SUNDRY NOTICES AND REPORTS ON WELLS
Do not use this form for proposals to drill or to re-enter an abandoned well. Use form 3160-3 (APD) for such proposals.

| 4. Location of Well (Footage, Sec., T., R., M., or Survey Description) Sec 18 T19S R34E NWSW 1800FSL 410FWL | | 8. Well Name and No. SCOUT 18 FEDERAL 01 ✓ / ✓ |

Conditions of Approval

Cimarex Energy Company of CO
Scout - 01, API 3002537890
T19S-R34E, Sec 18, 1800FSL & 410FWL
August 18, 2017

| Lease : Scout 18 Federal #1 | Perforations | | | Casing | | | |

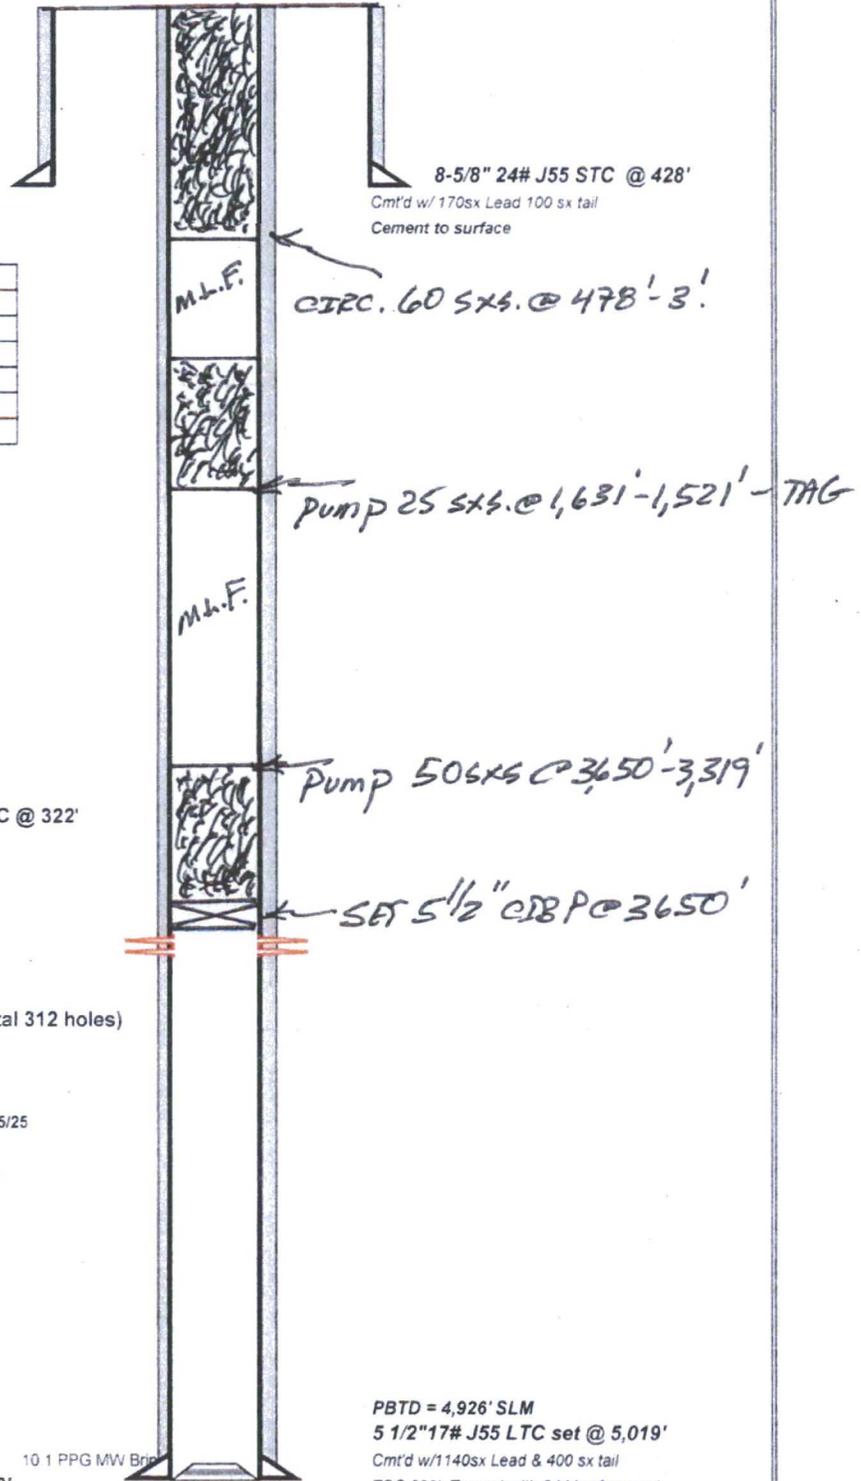
16. Tag w/tbg the balanced cmt plug set from 3650 at 3300 or above.
17. Set a balanced cmt plug across the Base of Salt from 3100. Tag the plug w/tbg at 2850 or above.
18. Set a balanced cmt plug across the Top of Salt from 1650. Tag the plug w/tbg at 1400 or above.
19. Set the Step 3 plug as written from 478 or below.
20. File **subsequent sundry** Form 3160-5 within 30 days of workover procedures. Include (dated daily) descriptions of the well work, i.e. procedure descriptions and setting depths of each plug in the subsequent sundry.

12. **Cementing procedure is subject to the next paragraphs.**
13. Mix cement plugs to cover a minimum of 100ft plus 10ft for every 1,000ft to the bottom of the plug, rounding the number of necessary sacks up to the nearest 5 sacks. Never use less than 25sx. Examples: A cement plug set at 8000 in 7" casing would require a min of 35sx. A 25sx plug in 5 ½" casing should cover 250ft, which may exceed 100ft plus 10ft per 1000ft.
